Poplin Ridge Stream Restoration Project

RE: Poplin Ridge Stream Restoration Site: MY7 Monitoring Report (NCDMS ID 95359)

Listed below are comments provided by DMS on November 5, 2021 regarding the Poplin Ridge Stream Restoration Site: Year 7 Monitoring Report and RES' responses.

On October 28, 2021, the Division of Mitigation Services (DMS) received the DRAFT Monitoring Year 7/ closeout report for the Poplin Ridge Stream Restoration Project from Resource Environmental Solutions, LLC (RES). The report establishes the year 7 monitoring and proposed closeout conditions at the site. Anticipated mitigation on the site includes 3,697 linear feet of stream Restoration; 3,305 linear feet of stream Enhancement (Level I); 953 linear feet of stream Enhancement (Level II); and 1,192 linear feet of stream Preservation for a total of 6,107.866 Stream Mitigation Units (SMUs) (R) and 238.400 Stream Mitigation Units (SMUs) (RE). The following are our comments on the DRAFT report:

Figure 2
6
Poplin Ridge Stream Restoration Project
MY7 2021
Current Conditions
Plan View

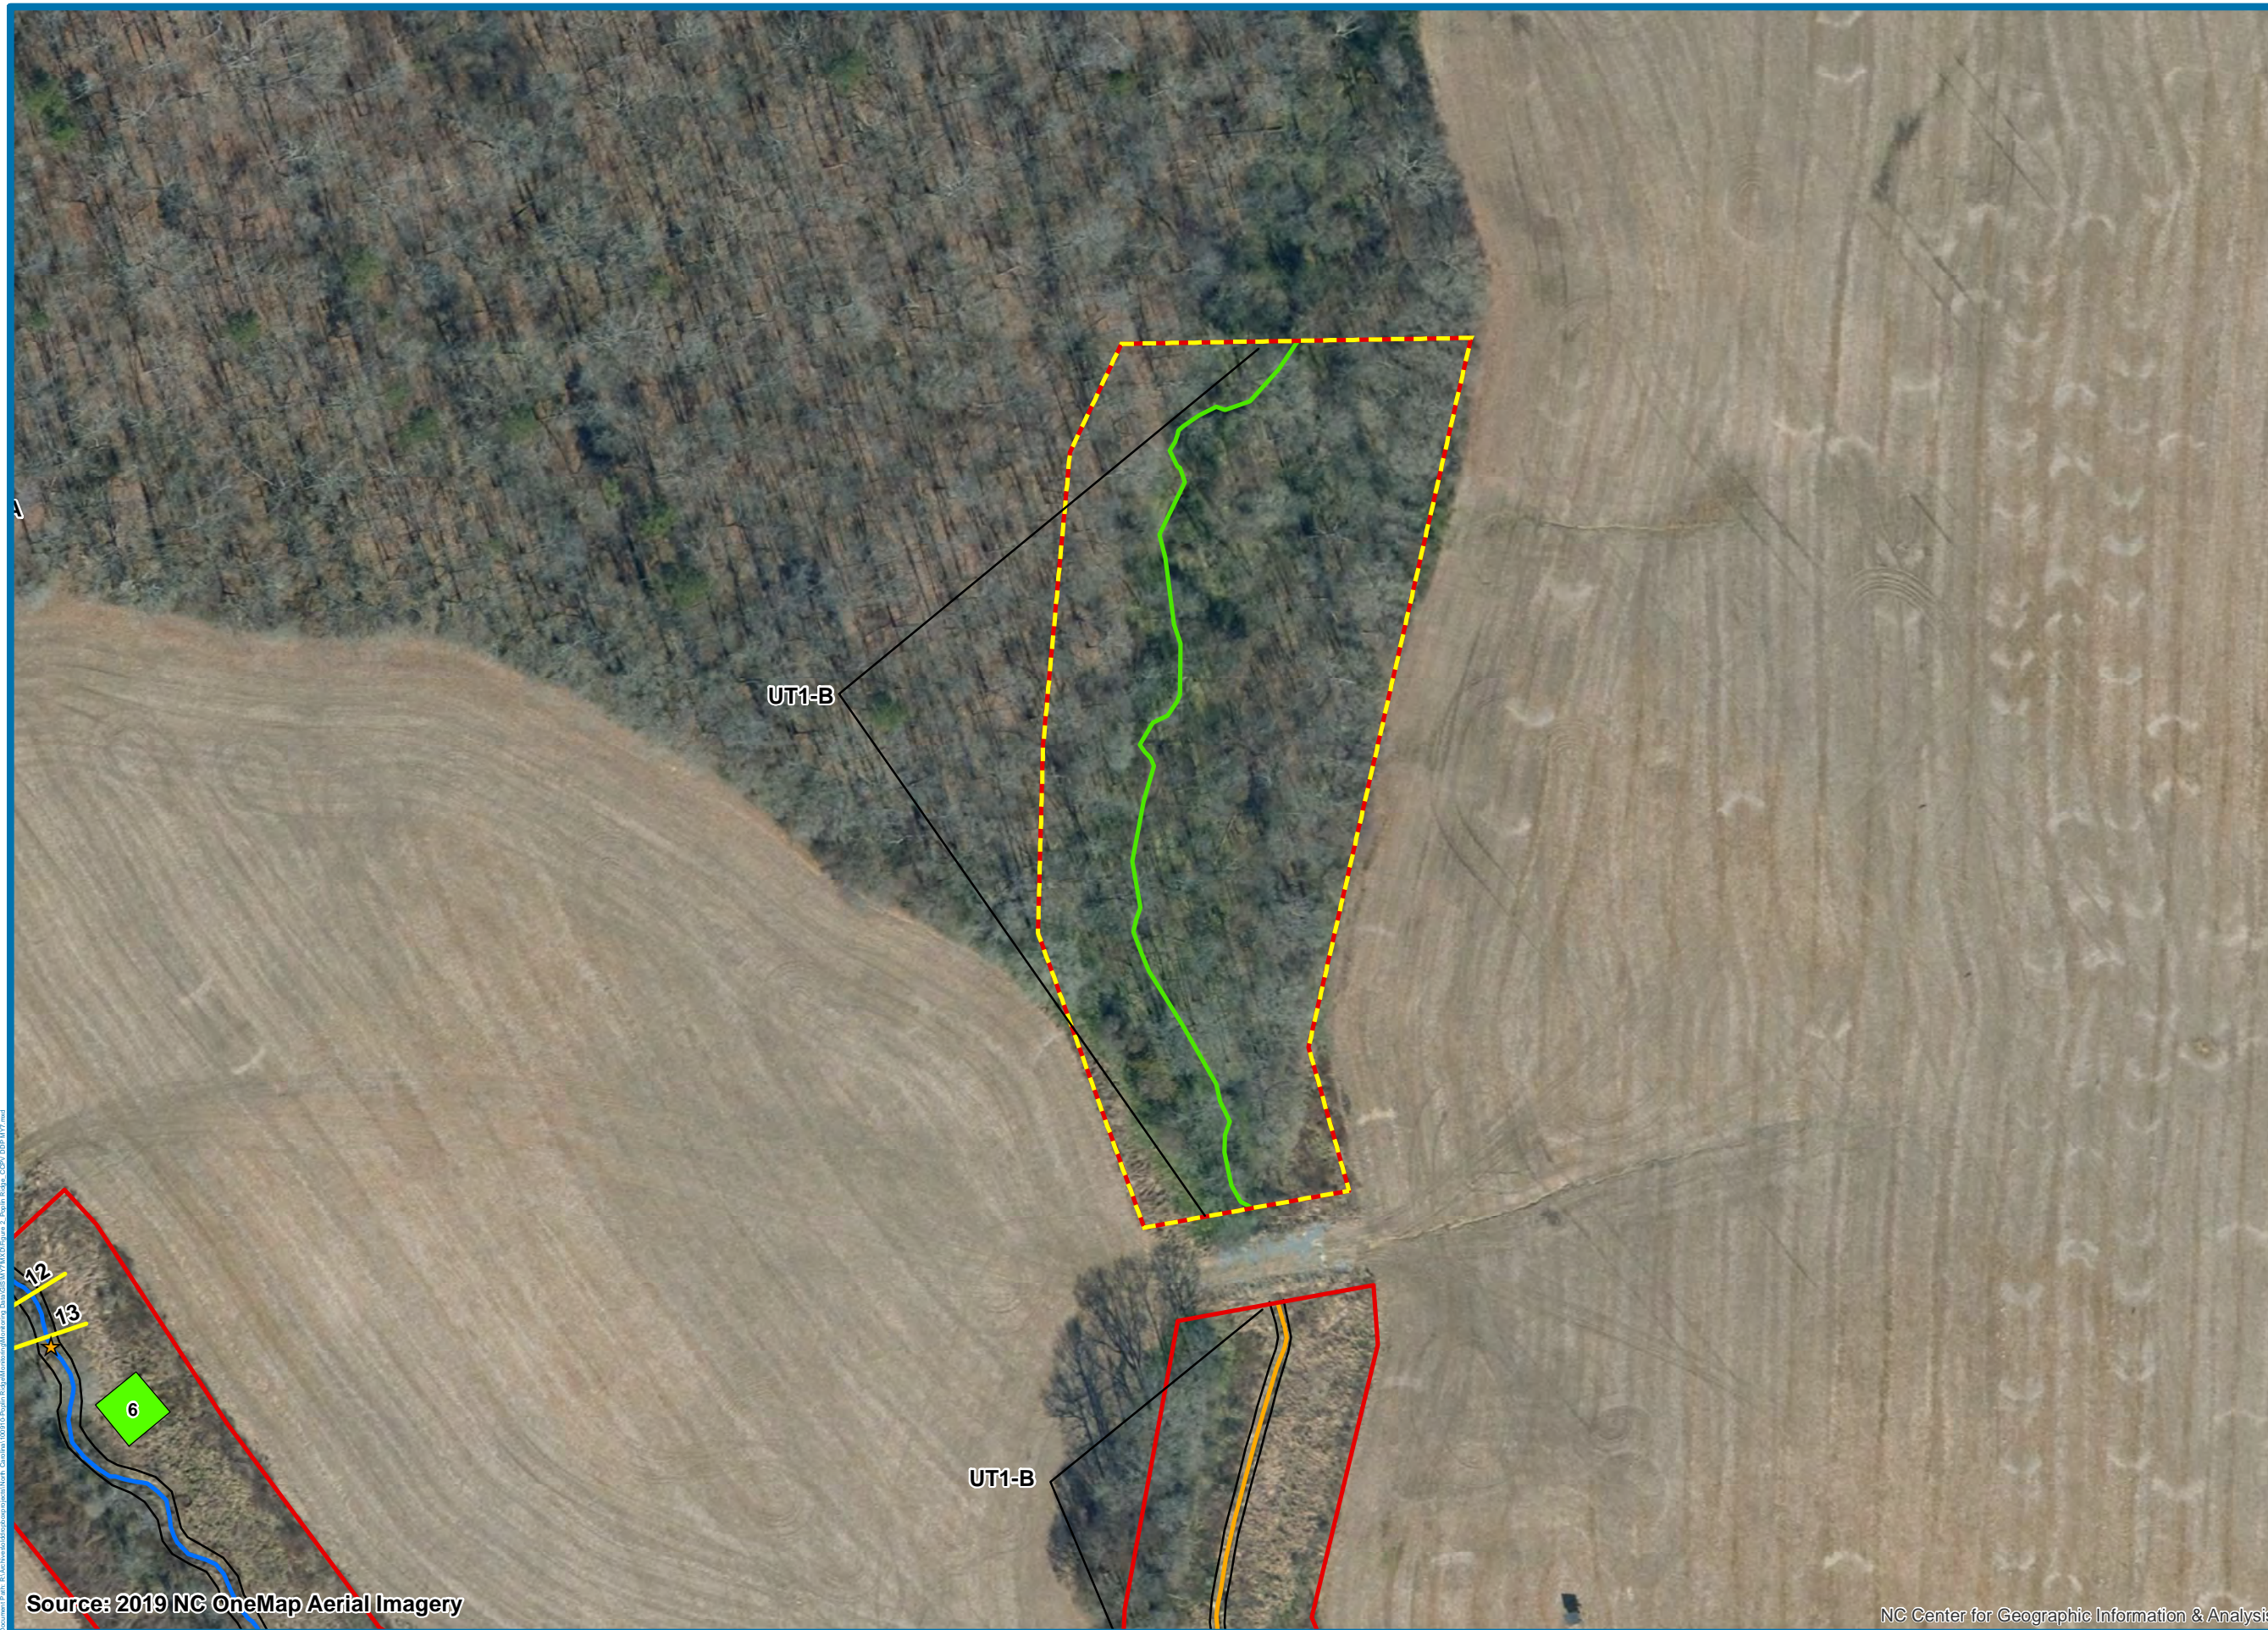
Section 1.4.3 Stream Hydrology: The report text notes stream flow results on UT2-A. Please show this flow gauge on the applicable CCPV map (Figure 2-6). This should also be updated in the MY7 digital support files (shapefiles).

[Done.](#)

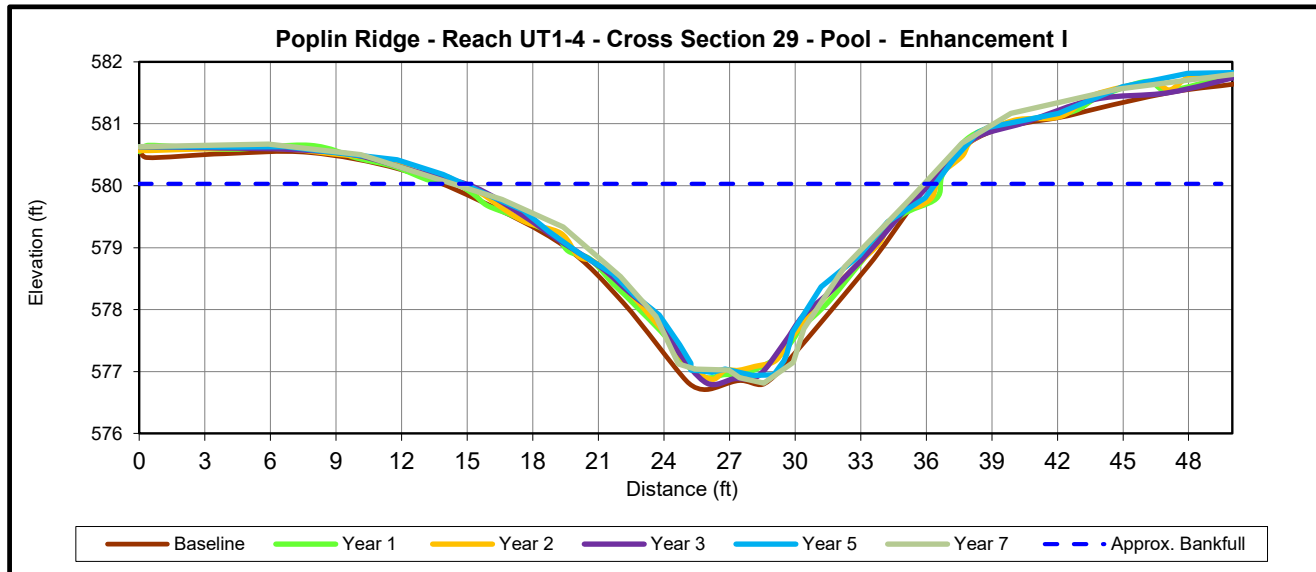
- Additionally, in the BHR workbook the bankfull elevation that achieves the MY0 cross sectional area for cross section 28 was calculated before excluding points outside of the main channel. The points outside of the main channel were also not excluded for cross section 4, and this may occur elsewhere. Note that failing to exclude these points will affect multiple parameters (e.g. BHR, cross sectional area, etc.), so please review and ensure these points are excluded for both the BHR and LTOB workbooks.

- Also note that when comparing the cross section 28 figure and table to Table 11a, it appears that the cross sectional areas are inconsistent. This may be caused by a mix up of data between cross sections 28 and 29. Please review and QA/QC all cross sections to confirm that they are reported accurately in the revised report.

Done.

Done.

MY7 2021 Poplin Ridge UT2-A Flow Gauge

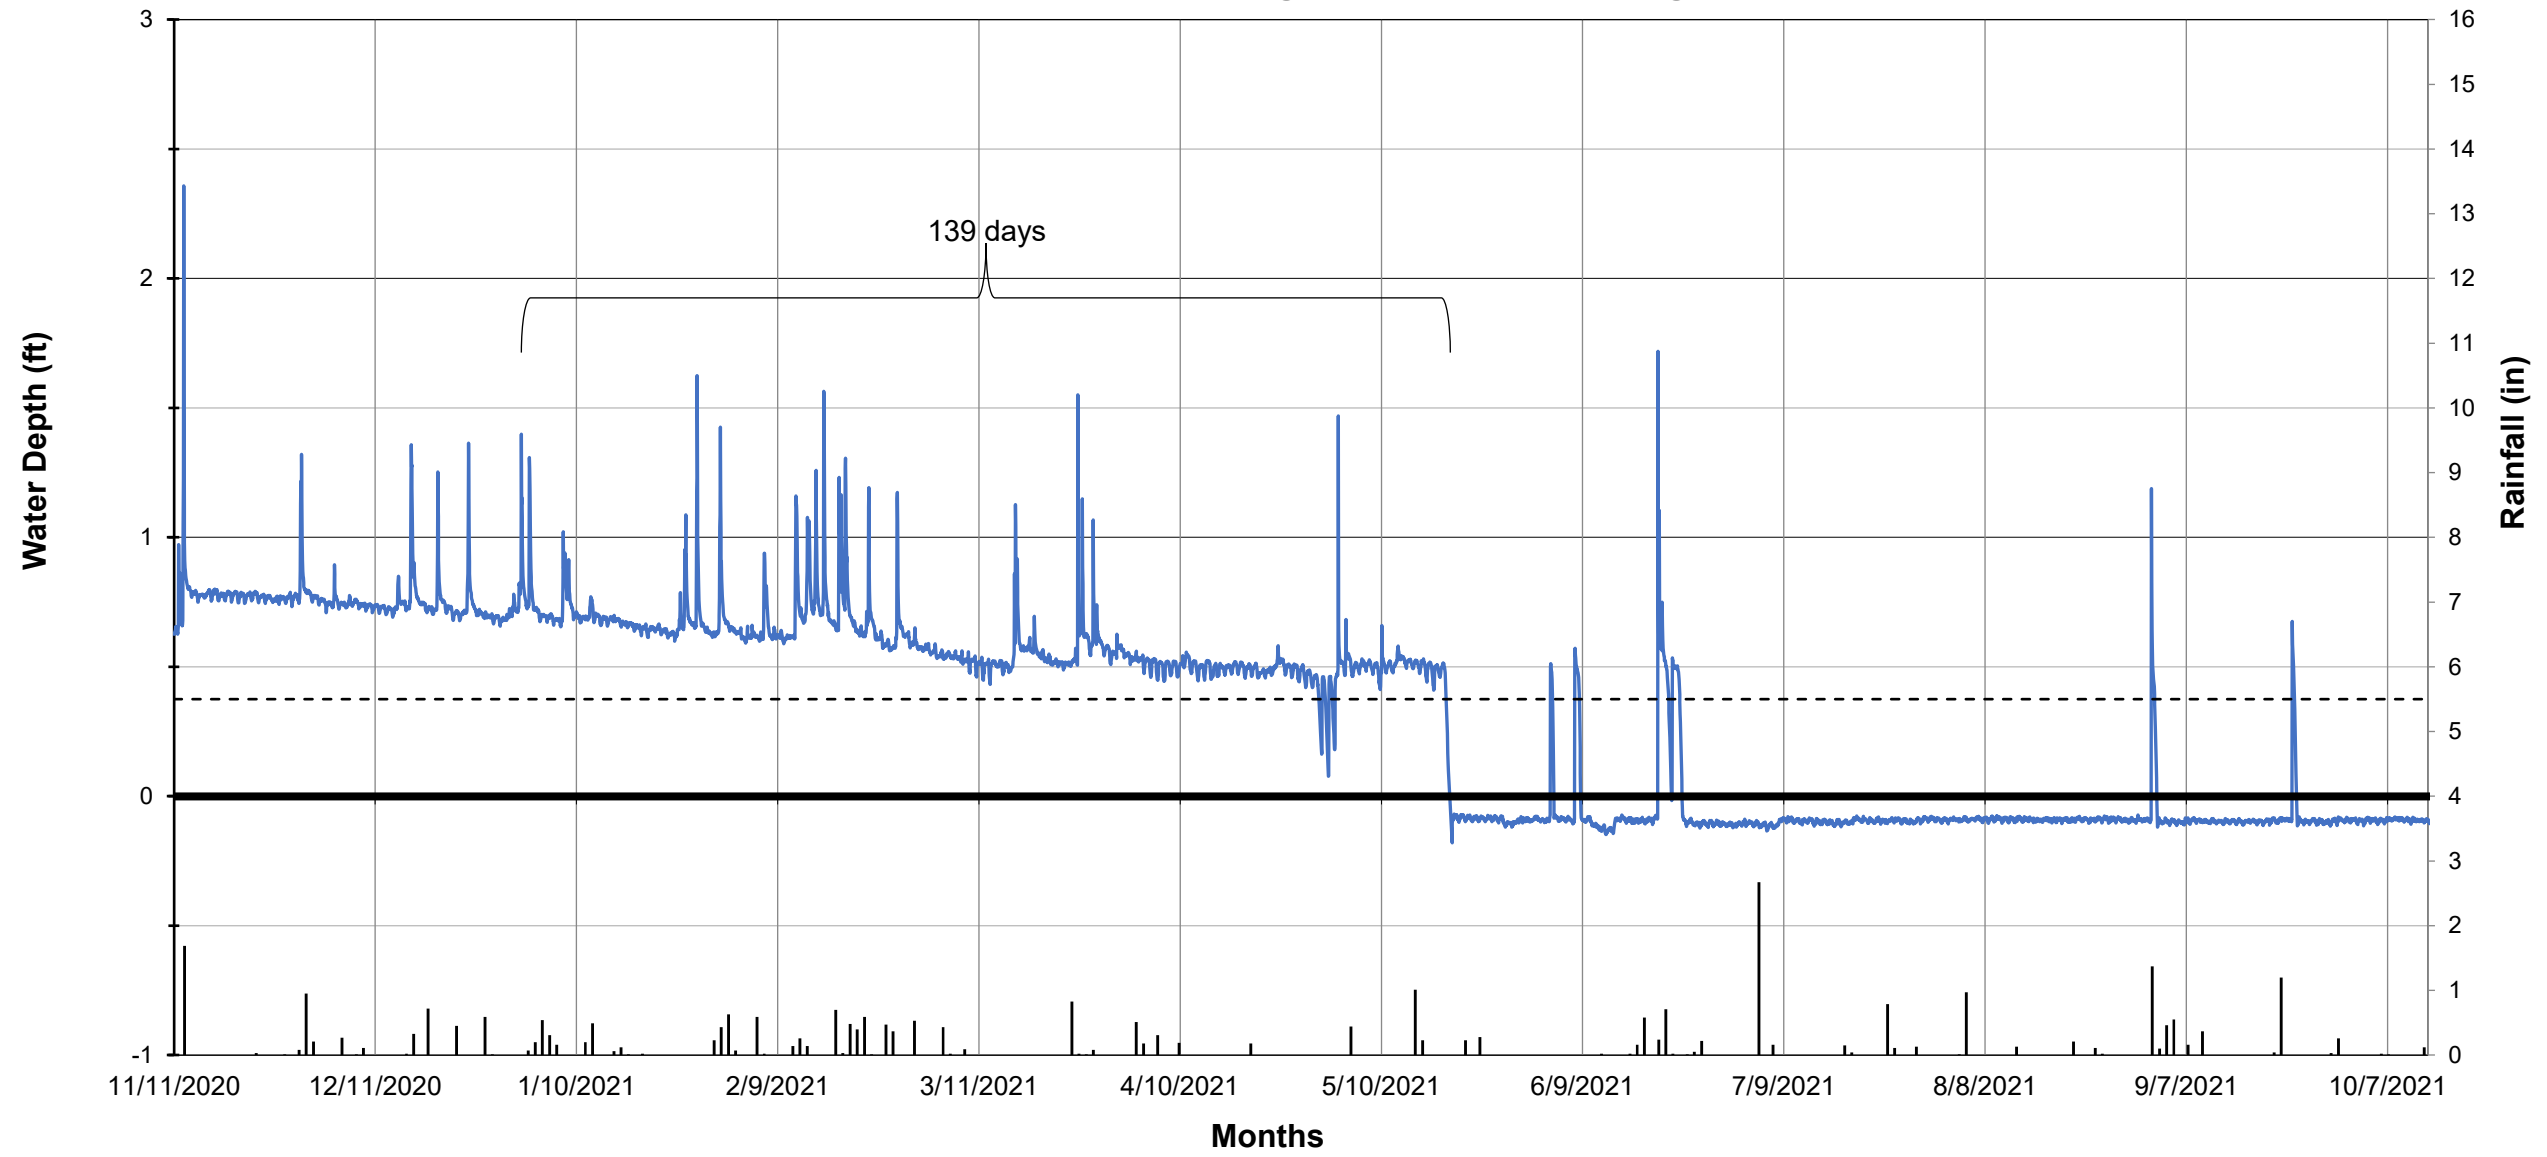
Appendix E – Flow Gauge Graph: DMS recommends showing the start and end points of the 139 days of consecutive flow reported.

Done.
